Subject: Duke Energy Corporation (Duke)
McGuire Nuclear Station Units 1 and 2
Docket Numbers 50-369 and 50-370
Technical Specifications Amendment
Request for Additional Information (RAI); TS 3.7.15 -
Spent Fuel Assembly Storage, and TS 4.3 - Fuel
Storage

**Responses to Nuclear Regulatory Commission Request for
Additional Information Related to McGuire Nuclear Stations's
License Amendment Request for No-Boraflex Credit**

Figure 17.1. Comparison of McGuire Discharge Fuel "Measured minus Predicted" Burnup Distribution with Normal Distribution Sample

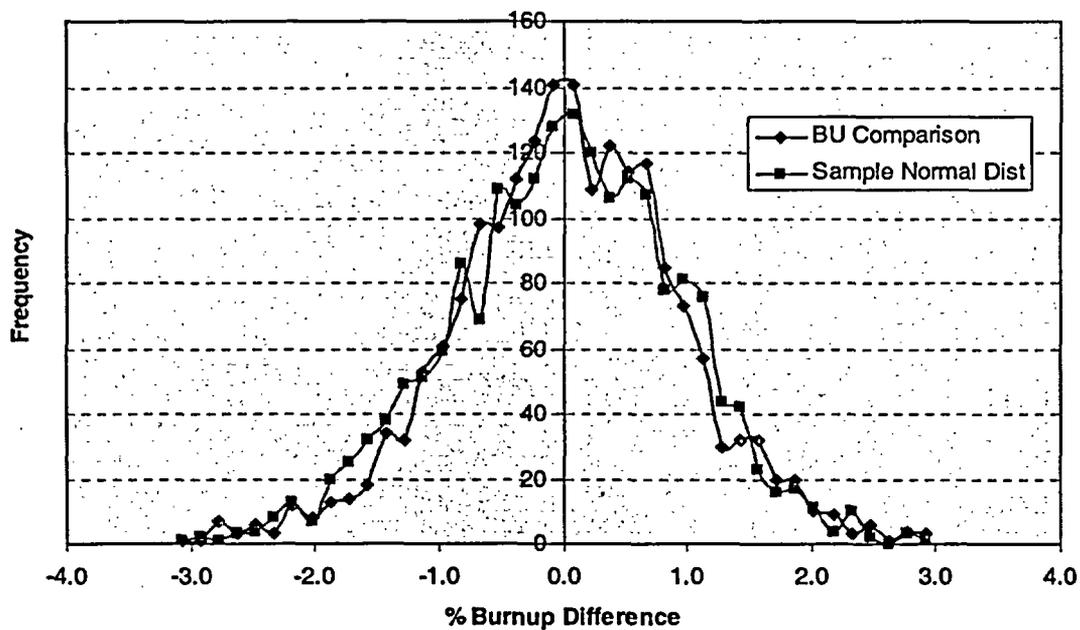
In Attachment 6, Section 8.2, the licensee stated that when predicted and measured burnup data was compared, the maximum individual assembly error observed was about 4.0 percent. The licensee then stated that "[w]hen an array of fuel assemblies large enough to affect system reactivity is evaluated for the McGuire SFP Region 2, and the distribution of predicted-to-measured burnup differences is accounted for, the maximum system reactivity increase observed is [approximately] 0.00125 delta-k." Please provide the following:

- a. An explanation of whether the determination of the maximum system reactivity increase is based on the maximum individual assembly error observed (about 4.0 percent) or on a distribution of observed predicted-to-measured burnup differences.
- b. If the maximum individual assembly error observed was used, provide a detailed explanation justifying why this error will remain bounding for future spent assemblies.
- c. If a distribution of observed predicted-to-measured burnup differences was used, provide a detailed description of how the distribution used to arrive at the 0.00125 delta-k value was selected and an explanation of why this distribution is bounding for all potential spent fuel loading configurations.

The burnup measurement uncertainty of $\pm 0.00125 \Delta k$ is based on an evaluation that considered the distribution of predicted-to-measured burnup differences, rather than the worst-case individual assembly error. This approach was taken because it has been observed that, for moderate reactivity differences

Sensitivity analyses demonstrated that 5.00 wt % W-RFA fuel with a 20-year cooling time produced the largest system reactivity increase per % burnup reduction. This fuel assembly type / enrichment / cooling time combination was thus used to evaluate the "average" burnup errors identified for the arrays in Table 17.1.

The Table 17.1 results show that the largest k_{eff} increase (0.00125 Δk) occurs with a 12x12 array of fuel, which has a worst-case average burnup error of 0.32%. This maximum burnup measurement uncertainty is judged to be appropriate and bounding for the following reasons:

Figure 18.1. Comparison of McGuire Discharge Fuel Axial Profile Δk (Actual Profile minus “Average” Profile) Error Distribution with Normal Distribution Sample

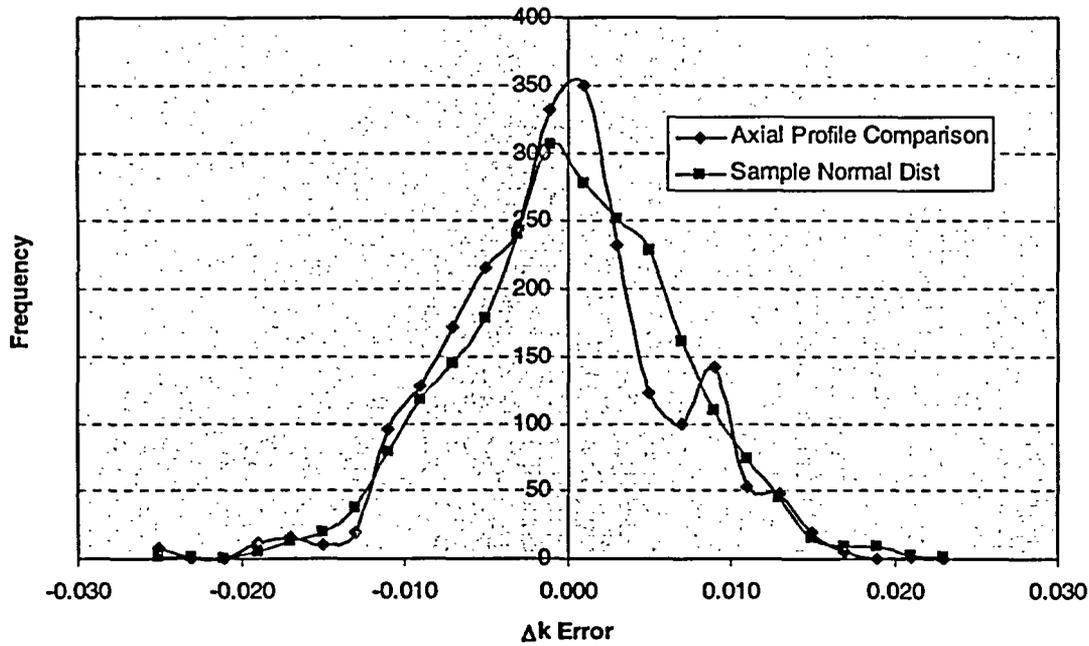
In Attachment 6, Section 8.2, the licensee stated that axial profile k_{eff} errors compare rather well with a normal distribution. Additionally, the licensee identified that the largest individual assembly axial profile error calculated is +0.030 delta-k. However, the licensee determined the bounding axial profile uncertainty by considering a group of fuel assemblies large enough to affect system reactivity and taking into account the distributions of axial profile k_{eff} errors within that group. The licensee determined that the bounding axial profile uncertainty is ± 0.00305 delta-k. Please provide detailed information on the methodology that was used to select the distribution used to calculate the axial profile uncertainty and why this distribution is bounding for all potential spent fuel loading configurations.

To quantify the axial profile uncertainty, the same statistical approach employed for the burnup measurement uncertainty - evaluating worst-case "average" reactivity errors for different array sizes - was used. The first step in this process was to gather the actual McGuire core follow axial history profiles, which had been used to generate the average (estimated) axial profiles for each McGuire fuel type and burnup range. These actual profiles were imported into individual SIMULATE-3 cases that computed k_{eff} s for all of these end-of-cycle core follow data points (McGuire 1 Cycles 1 through 15, and McGuire 2 Cycles 1 through 14). These same cases were then re-run using the pertinent average axial profiles from Attachment 6 of the LAR, Tables 10 through 16. After filtering the final discharge fuel data from these cases, the axial profile Δk differences were compared with a sample normal distribution with the same standard deviation. These distributions are shown in Figure 18.1. Note that, as with the measured burnup errors in Figure 17.1, the axial profile Δk errors have a slightly more peaked distribution than the sample normal distribution.

As with the burnup measurement uncertainty, the distribution of individual axial profile Δk errors was used to determine the largest feasible SFP system axial profile Δk uncertainty. Various arrays of symmetric assembly quartets were put together by randomly selecting assemblies (with replacement) from the large McGuire core-follow inventory. The random selection process was carried out with storage arrays ranging from a 2x2(x4) to a 6x6(x4) array. Over 2300 random samples were taken for each of these arrays. For each of these samples, the "average" axial profile Δk error was determined by taking the average of the individual Δk errors within the pertinent array. The resulting "average" Δk errors were then sorted, and the highest "average" error for each array size was conservatively taken for specific analysis of the maximum feasible system axial profile uncertainty. Table 18.1 documents these maximum "average" Δk errors for each of the array sizes selected. Note that for each of these maximum "average" Δk errors, a single assembly from the McGuire core follow database was selected with the matching Δk error for that particular array size.

For each case listed in Table 18.1 the center array within the total 12x12 system matrix used the actual axial history profiles from the core follow data of the chosen fuel assembly for that particular array size. Any surrounding assemblies making up the balance of the 12x12 system matrix used the pertinent "average" axial profiles (from Tables 10 through 16 in Attachment 6) for the chosen fuel assembly. The Table 18.1 results show that the largest system k_{eff} increase occurs with a 6x6(x4) array of fuel, which yields a worst-case average axial profile error of 0.00305 Δk . This maximum axial profile uncertainty is judged to be bounding for the following reasons:

- The uncertainty is based on the worst observed case of randomly selected real McGuire discharge fuel, with the conservative assumption that symmetric quartets of fuel assemblies remain stored together.
- The 12x12 array that yielded the highest k_{eff} increase is conservative because this is the total problem size; that is, there is no surrounding fuel in the model, so this is essentially an infinite array of fuel with a worst-case axial profile error of $\pm 0.00305 \Delta k$.
- For each of the fuel types documented in the LAR, including the W-RFA and MkBI assemblies, a conservative average burnable poison exposure profile was employed for all fuel burnup. The use of these conservative profiles for McGuire fuel is evident in Figure 18.1, which shows a slight negative bias ($-0.0006 \Delta k$).
